**AGENDA FOR THE MONDAY SEPTEMBER 11, 2017**  
**PLANNING COMMISSION HEARING – 7:00 PM**

## **H.B. STORAGE ADDITION**

PRELIMINARY PLAT OF:  
**H.B. STORAGE ADDITION**

## 9-11-17 Planning Commission Draft Findings

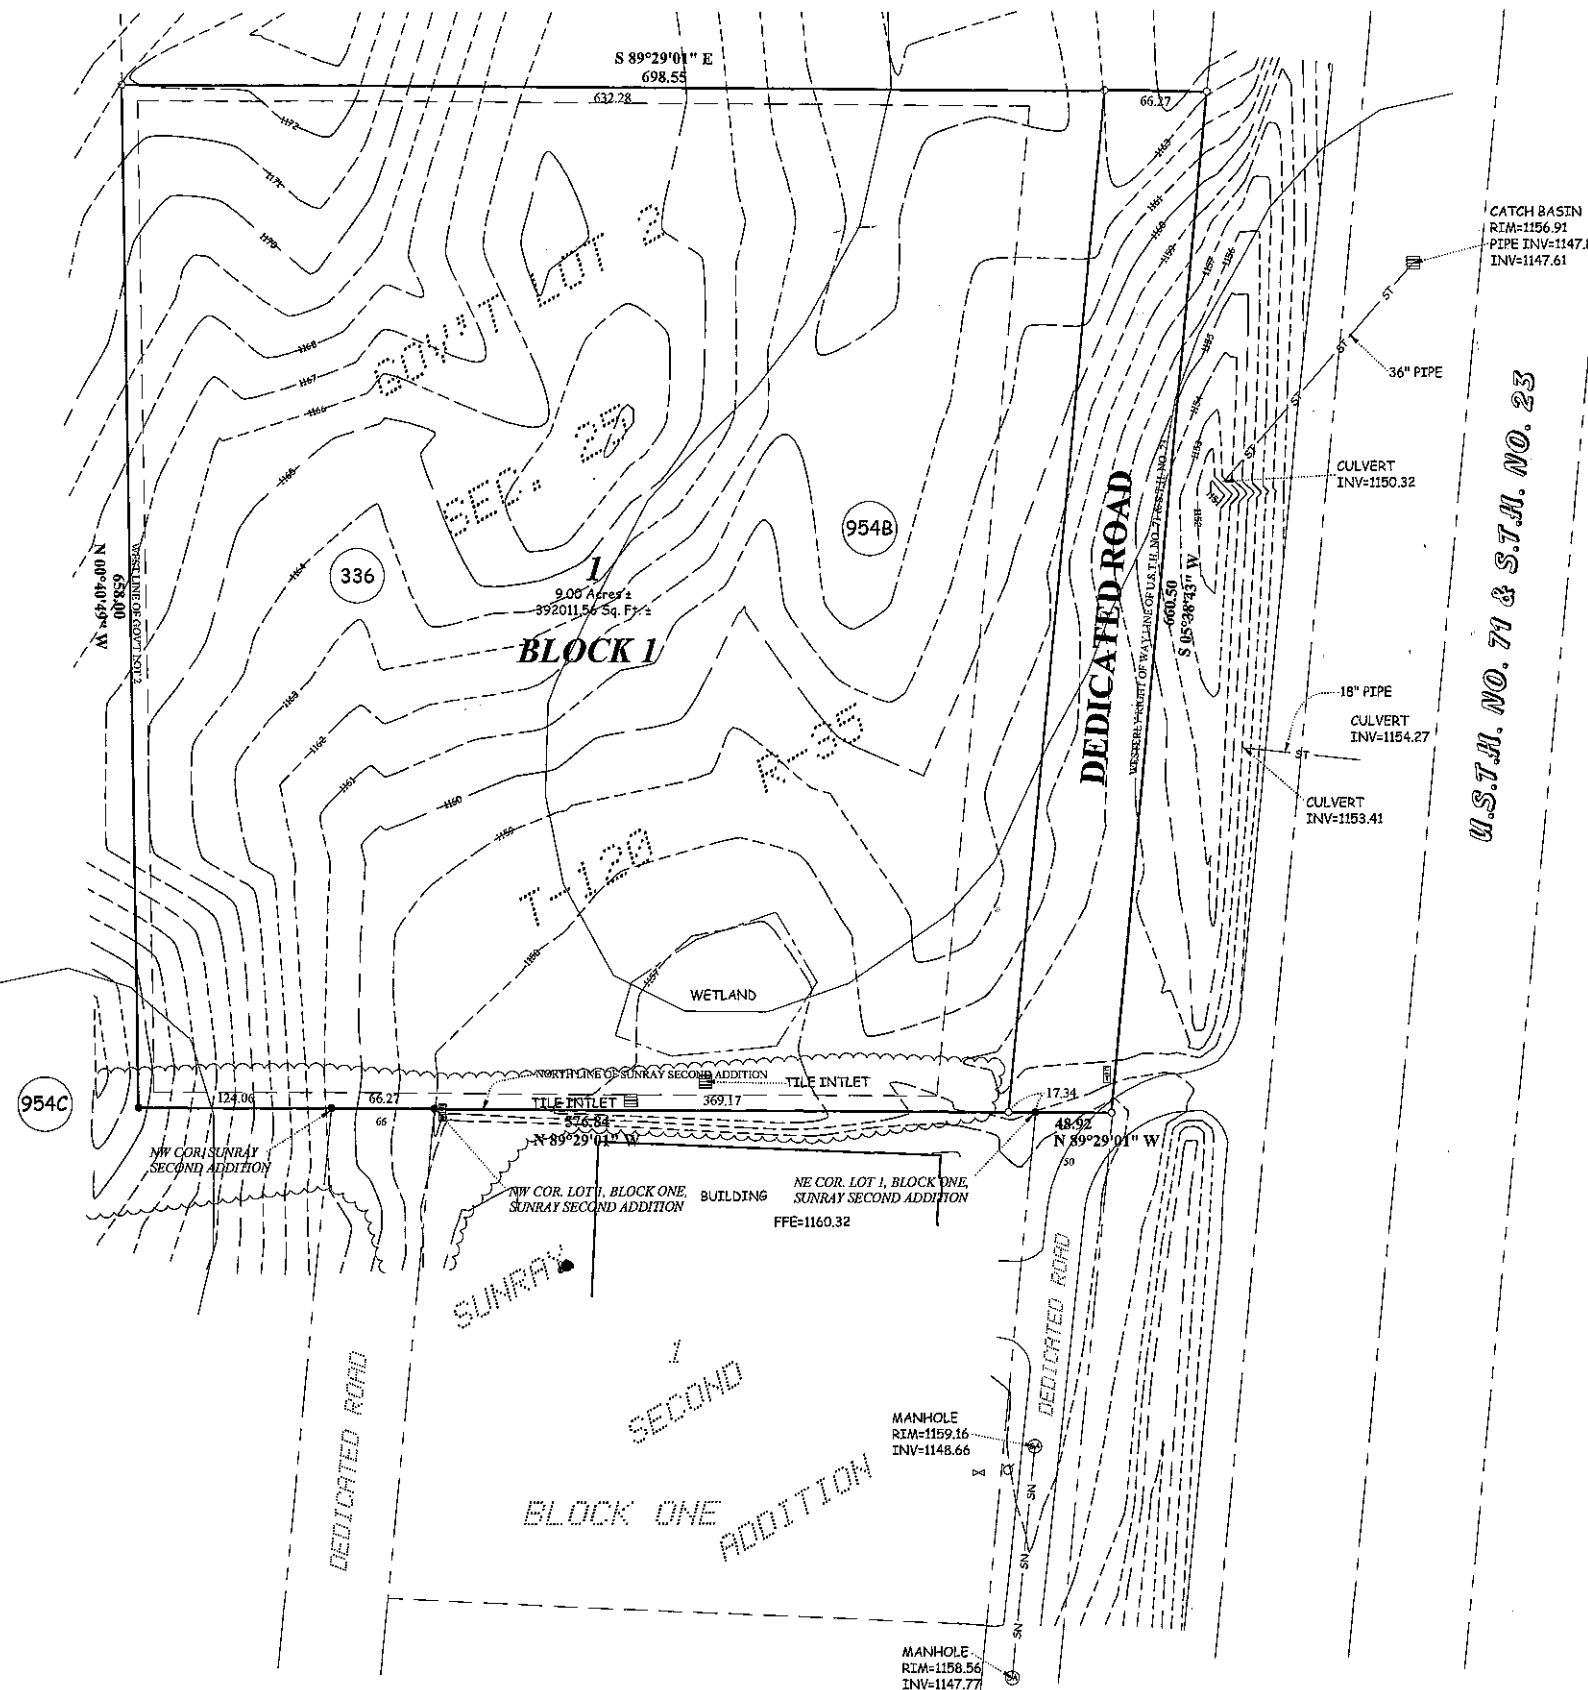
This preliminary plat proposal has been reviewed against the standards of the Zoning Ordinance and Subdivision Ordinance and found to be meeting all applicable standards. The plat lies within the urban growth boundary of the City of Willmar, is adjacent to a trunk highway, has sewer service availability, and is adjacent to existing commercial/industrial uses, making it a prime location and proposal for additional development within the county. In keeping with modern development standards, the plat has been planned to have adequate space and dimensional characteristics to serve proposed needs, to allow for an appropriate amount of green space, to handle stormwater runoff without burdening the broader ecosystem, and to properly plan for and to install a safe and modernly designed access/frontage road with contingency for road extension in the future.

Some level of concern has been expressed to staff from individual Dovre Township Supervisors and from Mel Odens, County Engineer, regarding the presence of yet-undeveloped dedicated road (18<sup>th</sup> St NE) that dead-ends on the southern line of the proposed plat. Concern has been expressed regarding the shape and alignment of the proposed plat that would essentially preclude (once developed) potential future extension of 18<sup>th</sup> St NE to the north. This section of dedicated roadway is undeveloped for a distance of over one quarter mile to the south, making it impossible for the landowners/developers to consider this section of dedicated road as the means of access to the proposed plat. The proposed lot has been configured with frontage road access (as has been developed to the south of this plat) and with dimensional characteristics that serve well the needs of the prospective commercial use. Inasmuch as there is no Comprehensive Plan or Ordinance language that would compel a developer to provide for, dedicate, and develop multiple roadways for access, such a requirement would appear to be unduly burdensome to the developer who has proposed and is prepared to develop a frontage access road as required in ordinance. It is conceivable that the western boundary line of the proposed lot could be reconfigured in such a way that the lot maintains significant dimensional integrity while also allowing for potential future dedication and development of 18<sup>th</sup> St NE.

Staff recommends approval of the preliminary plat based on the fact that the preliminary plat meets all subdivision and zoning ordinance requirements for proposed development and the fact that the preliminary plat fits the purpose and intent of the CI zoning district. If the Planning Commission is sufficiently concerned about and convinced of the need for potential future development of 18<sup>th</sup> St NE, staff recommends approval of the preliminary plat contingent upon reconfiguration of the west property line and the stormwater management plan in such a way that future northerly development of 18<sup>th</sup> St NE is not precluded, which changes are to be evident in presentation of the final plat.

The Planning Commission gives approval to the preliminary plat based on the fact that the preliminary plat meets all subdivision and zoning ordinance requirements for proposed development and the fact that the preliminary plat fits the purpose and intent of the CI zoning district. Additionally, the Comprehensive Plan states that "Commercial Development along highway corridors, especially in areas that are currently established as commercial developments, can provide for orderly growth patterns and minimize the chance for incompatible land uses (ref. chapter 6, page 5).
